CITY OF BOULDER
LAND USE REVIEW RESULTS AND COMMENTS

DATE OF COMMENTS: **March 11, 2005**
CASE MANAGER: **Brent Wilson**
PROJECT NAME: **"West Mountain Heights"**
LOCATION: **2641 4TH ST**
COORDINATES: **N04W08**
REVIEW TYPE: **Concept Plan Review & Comment, Rezoning, BVCP Land Use Designation Change**
REVIEW NUMBER: **LUR2004-00089 and LUR2005-00012**
APPLICANT: **MOUNT SANITAS**
DESCRIPTION: **CONCEPT PLAN REVIEW AND COMMENT, REZONING, BOULDER VALLEY COMPREHENSIVE PLAN LAND USE DESIGNATION CHANGE: A new mixed density, 42-unit residential development with a proposal to amend the Boulder Valley Comprehensive plan to OS, LR and MR and a re-zoning to MXR-D.**

Existing Neighborhood

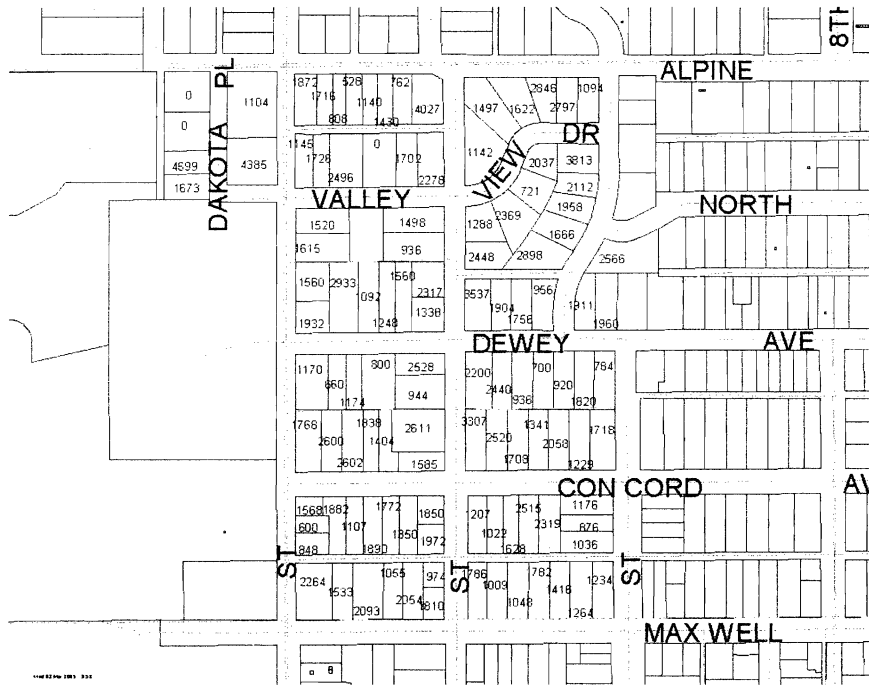
The existing neighborhood includes a mix of housing types, but it is primarily single-family in character. Of the 125 units surveyed within the 27.79 acre "neighborhood area," 98 (78.4%) are single-family detached, 24 (19.2%) are configured as part of a duplex and three (2.4%) are configured as part of a triplex. Although row houses exist south of the neighborhood area on Mapleton Avenue, they are not part of the immediate neighborhood context.

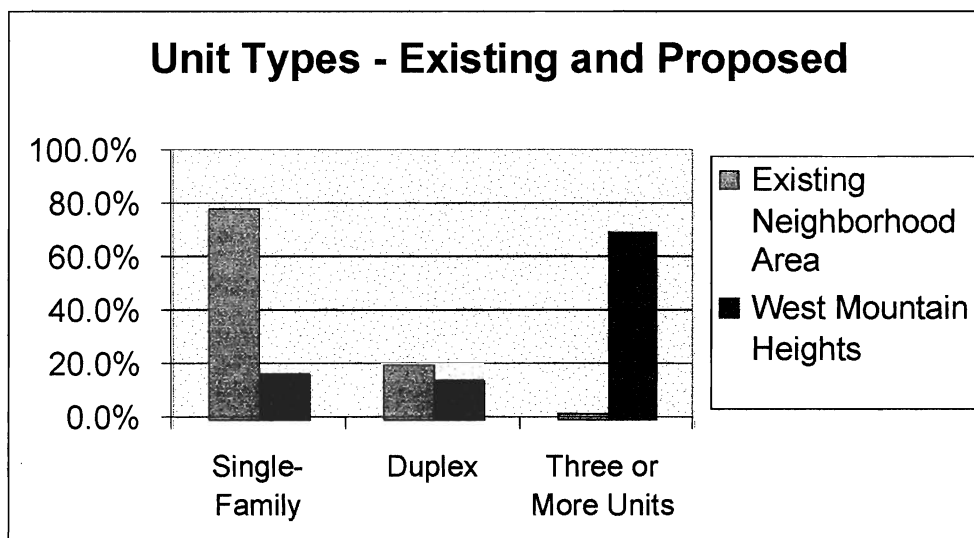
It is fair to describe the existing neighborhood area as "eclectic" with regard to unit sizes and configurations. However, staff finds the proposed "West Mountain Heights" unit sizes and configurations are out of context with the existing neighborhood character. For example, the existing streetscape along 4th Street is characterized primarily by single-family homes ranging from 600-2,200 s.f. while the "West Mountain Heights" proposal provides streetscapes characterized by row houses in the 11-12,000 s.f. range on both sides of the street.

Although attached housing units may be supported by staff, the current plan does not provide a framework that extends the established character and fabric of the neighborhood. It is recommended the homes along Dewey Avenue and 4th Street be configured in a manner consistent with existing homes along these streets. Attached units may be more appropriate towards the western portions of the property.
